An Bord Pleanála  
64 Marlborough Street,  
Dublin 1, D01 V902

19th August 2021

Re: 310860: Holy Cross College, Clonliffe Road, Dublin 3 and Drumcondra Road Lower, Drumcondra, Dublin 9.

## 3. Unit Mix

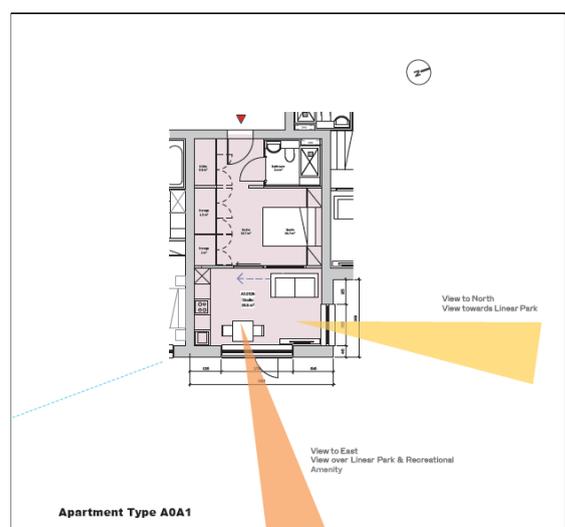
This proposed development is in contravention of the Dublin City Development plan and does not make valid reasons for doing so. Dublin City Development plan 2016-2022 estimate of the distribution of dwelling sizes per bedroom required to meet projected demand: 1 bed 20%, 2 bed 40%, 3 bed 30%, 4 bed 10%, 5 bed 5%.

This development does not meet the objectives of Dublin’s Housing Strategy. QH1: To have regard to DECLG guidelines on Quality Housing for Sustainable Communities - Best practice guidelines and sustainable residential development in urban areas and the accompanying Urban Design Manual.
